ENVIRONMENT PROTECTION ACT 1970

WORKS APPROVAL APPLICATION ASSESSMENT REPORT

Application No.	1002260
Applicant Name	Wyndham City Council
Address of Premises	470 Wests Road, Werribee, 3030
Proposal	Extension of landfill operations for disposal of putrescible and solid inert waste

Figure 5: Flood_Extent_100yr_Waterways' GIS layer – Magenta cloud indicates anomaly.

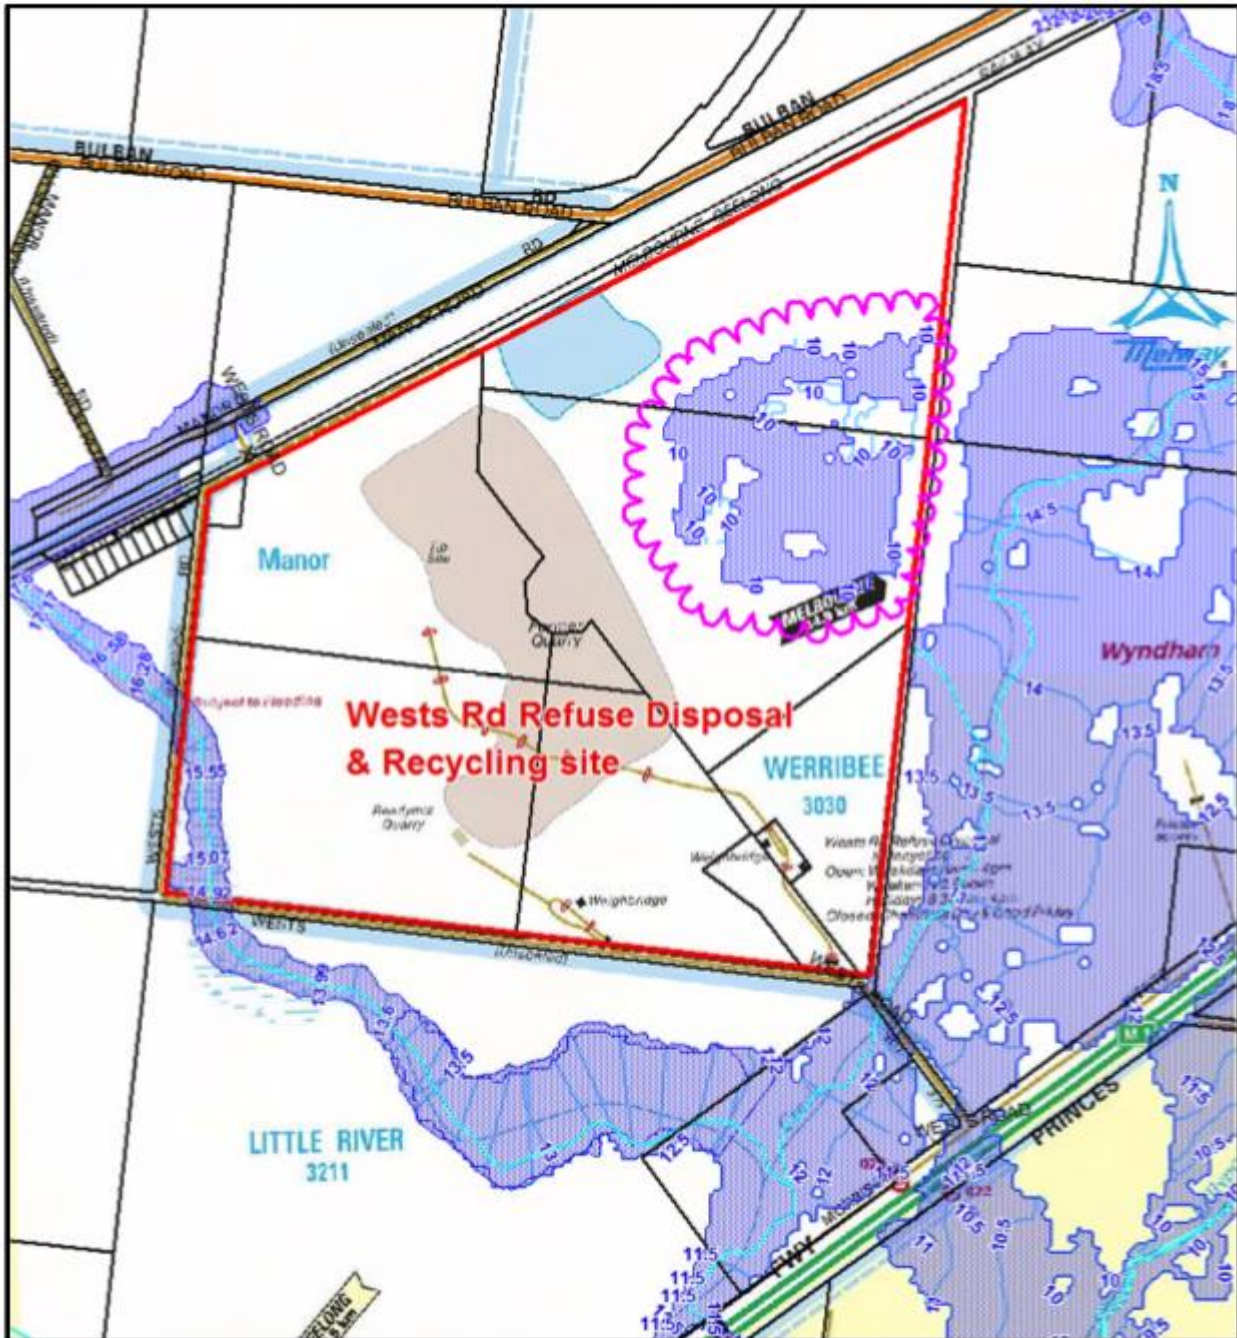
- 2.18 Advice was sought from Melbourne Water (MW) concerning the flood risk and an apparent anomaly in the 1:100 flood overlay for the region which showed that the North-East corner of the site would be subject to flooding.
- 2.19 The full response received on 14 August 2017 is provided in Appendix C.6. In summary MW advised that there was an anomaly in the flood mapping as follows:
- *“In updating the ‘Flood_Extent_100yr_Waterways’ GIS layer with the latest mapping work, please ensure that the original flood extent adjacent to the eastern boundary of the Wests Rd Refuse Disposal & Recycling site (surrounded by magenta cloud in below plan [see Figure 5]) is removed as it was an anomaly in the original flood mapping. There is another small section of waterway flood extent cutting across the southwest corner of the site which is still valid and should remain.”*

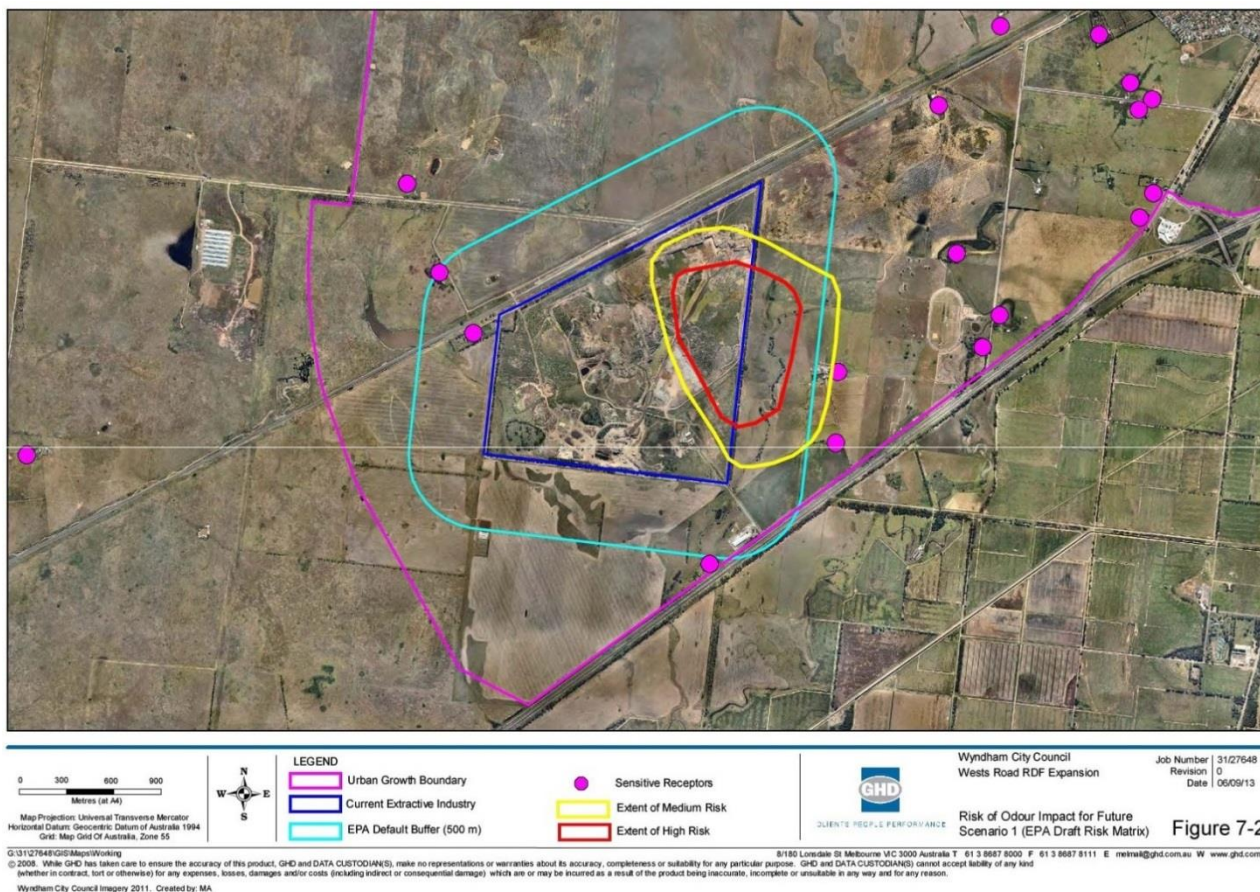
But the odour model drawn up by Wyndham Council's consultants, GHD (October 2013, Annex K "Odour Dispersion Modelling Assessment"), shows that there is at least a *medium risk*⁷ of odour travelling beyond the site boundary (including beyond the buffer zone and to nearest residences) contrary to licence and BPEM requirements:

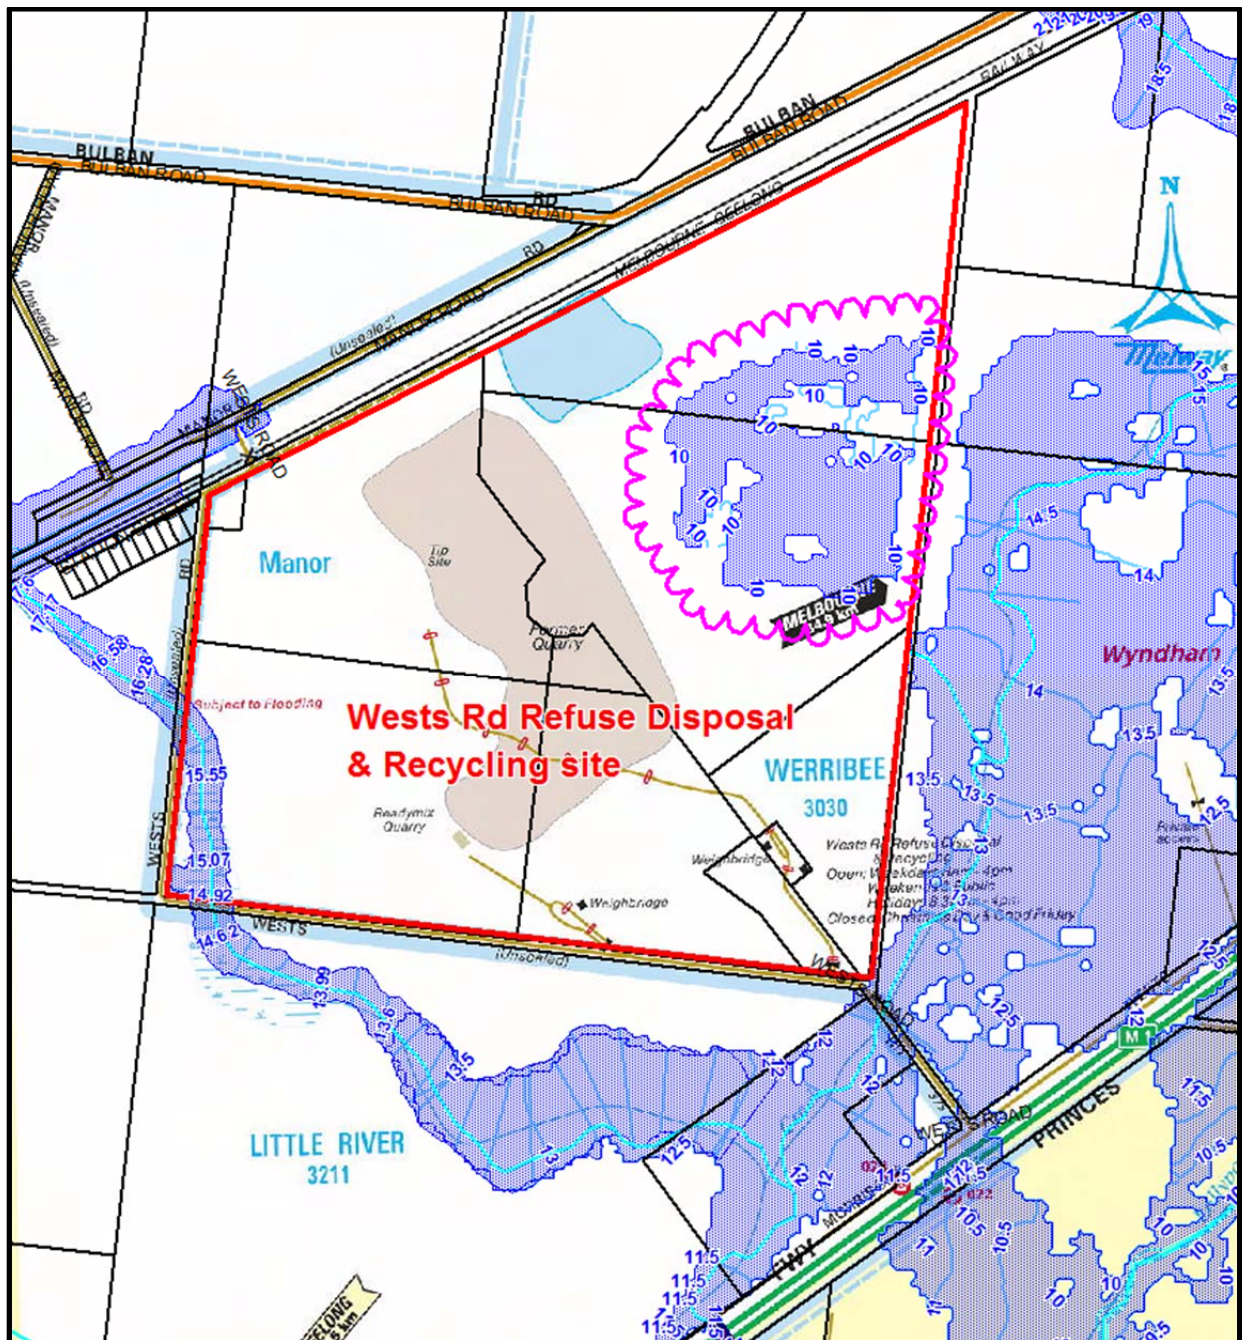
Since the extent of the model cut through the former quarry site with quite a deep hole, the modelling would have commenced its distribution of inflow directly into the bottom of the former quarry hole as this is the lowest point in the DEM.

The flood extent within the quarry hole should have been identified as an anomaly by WBM but as it was remote from WTP, for which the mapping was being undertaken, it is understood how it could have been overlooked. It should have been eliminated in the review of the mapping work for inclusion in the 'Flood_Extent_100yr_Waterways' GIS layer but it wasn't.

Figure 2 Schematic cross section of swale assets constructed on a traverse requiring land take in addition to the flood water “top width”

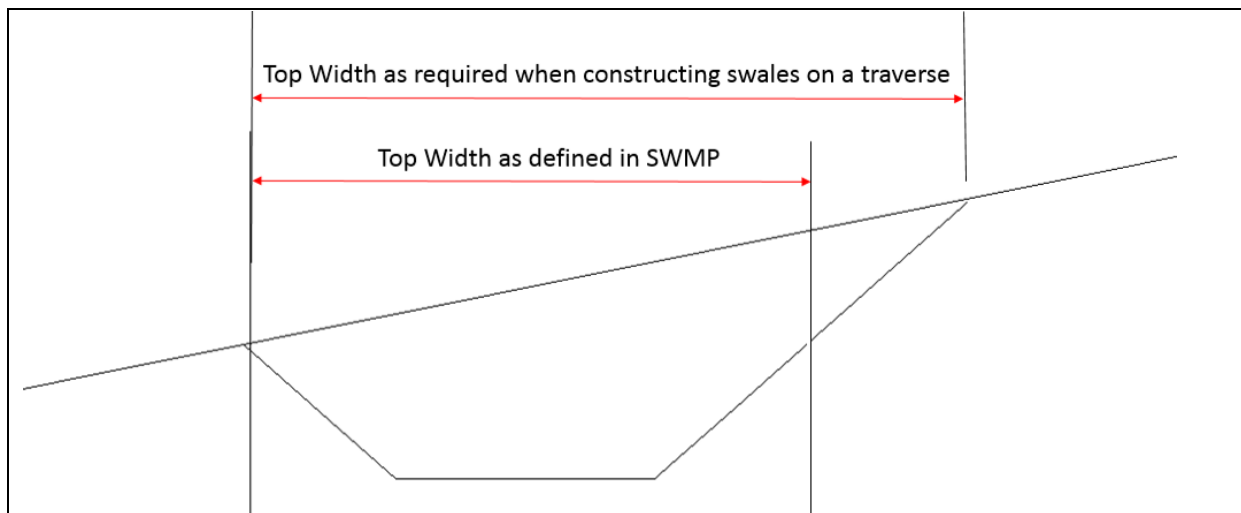
In regard to the swales they will need to be constructed on a traverse slope in the order of 1 in 5 (in some cases). As detailed in Figure 2 below this adds to the total width requirement of the asset. If vegetated swales are utilised, SWS preliminary calculations indicate that this could result in swales in the order of up to 8.5 metres wide being required in some locations.

- The swale systems are just detailed as lines. Swales are required to be clearly shown in regard to “land take” (see Figure 2 above). All swales require a 1/300 (min) fall over the swale length.
- Adequate delineation of all detention ponds is required including specifying proposed normal water levels, batter requirements, spillway levels, crest requirements etc. to ensure adequate space has been allocated on site.
- The final cap will be prone to settlement over time. The impact on the integrity of the drainage swales and ponds located on the cap over time should be covered via implementing the inspection and maintenance program in regard to this issue.

Figure A.2 Stage 1, 1% AEP Inflow into P13 RORB Results

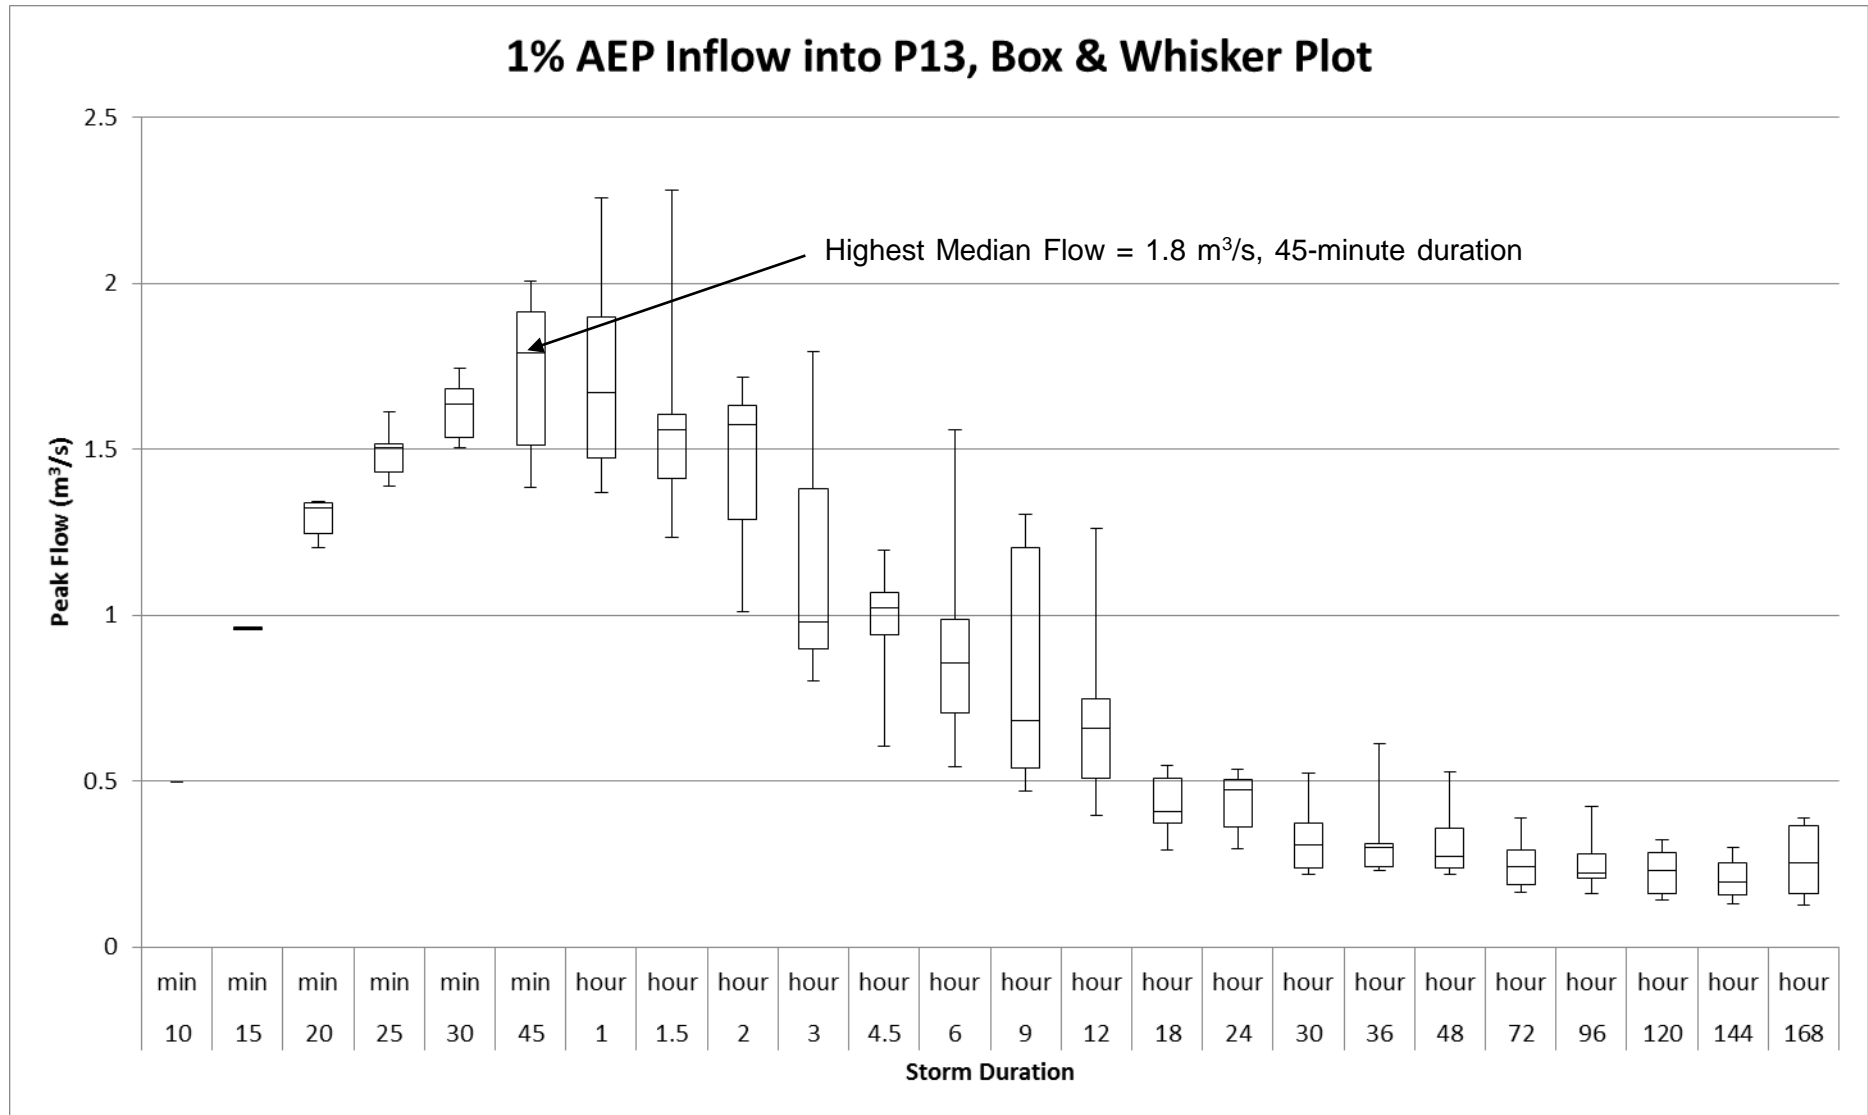
As such the results for all 1% AEP (100 Year ARI) simulations into Pond P13 are shown in Figure A.2 with the critical 1% AEP inflow into P13 being 1.8 m³/s (45-minute duration, TP26).

Figure A.3 5% AEP 24-hour Storm hydrographs simulated

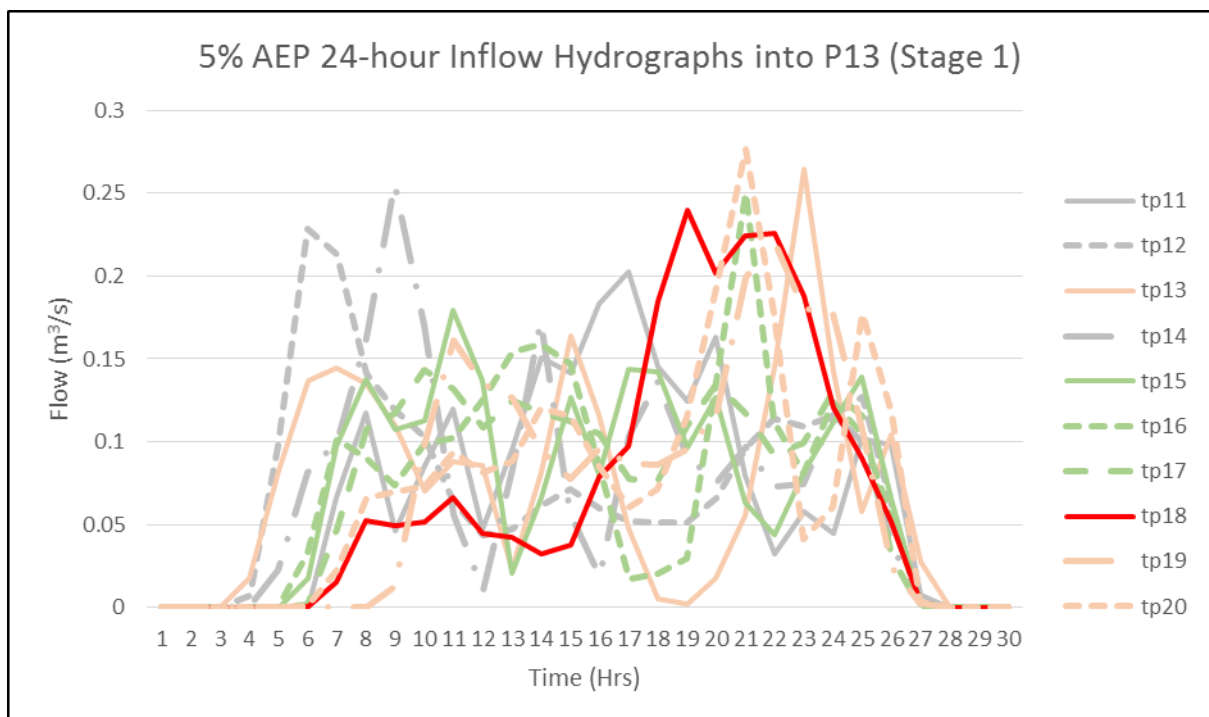
The RORB inflow hydrographs into P13 for the ensemble of the 24-hour storm event are shown in Figure A.3. For the 5% AEP 24-hour event, the median inflow volume to P13 is 7560 m³ (TP18). This is slightly larger than the Tonkin SWMP value of 6720 m³.

The above analysis indicates that the 2017 SWMP gives a reasonable estimate of the 5% AEP inflow volume to Pond P13, assuming the critical inflow volume occurs for a 24 hour critical duration.

Figure 2 Stage 3, 5% AEP Inflow into P13 RORB Results

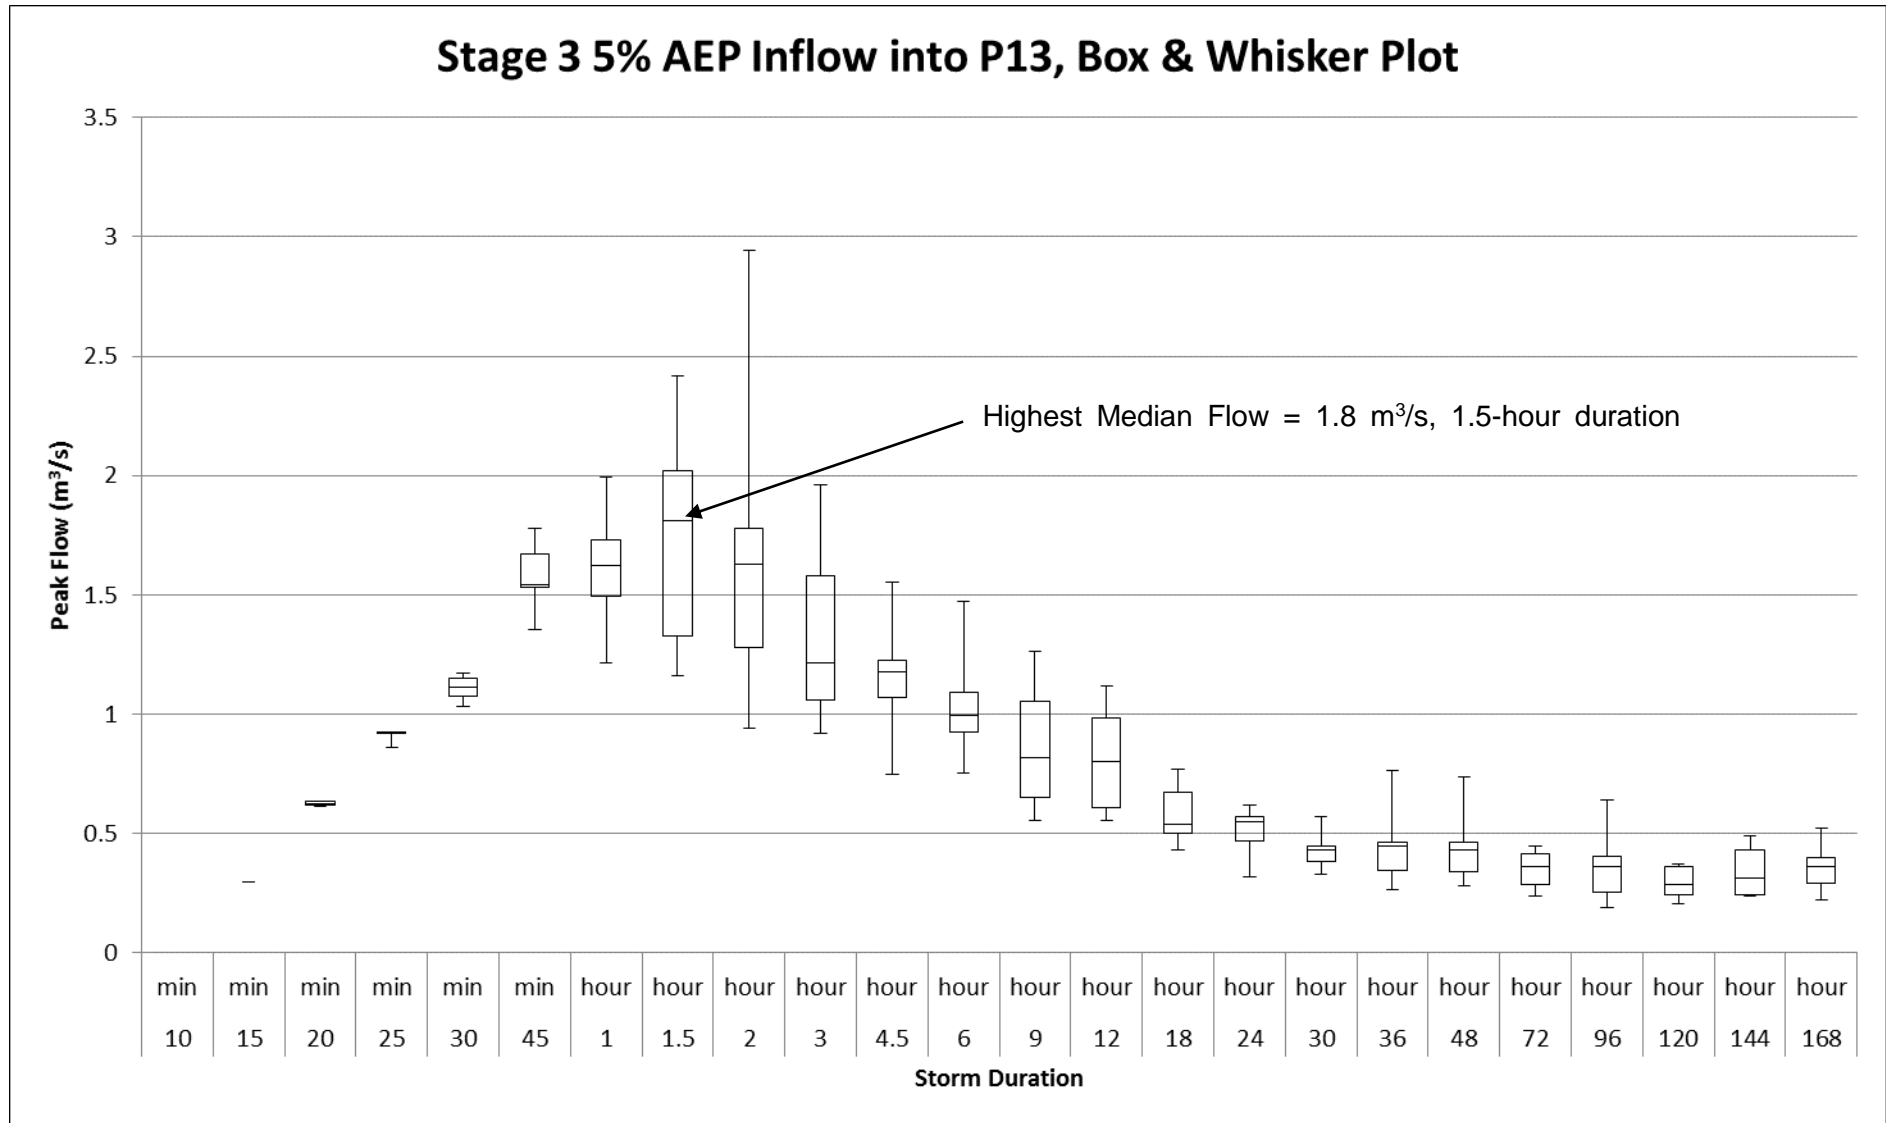
Figure A.5 below details all simulations run (for 5% AEP flow into P13) and details how the median value reported in Table A.8 is determined.

The critical 1% AEP inflow into P13 has been determined as 3.7 m³/s (45-minutes, TP26). It is assumed that Pond P13 will not be required in Stage 3 as all contributing area will incorporate their final capping.
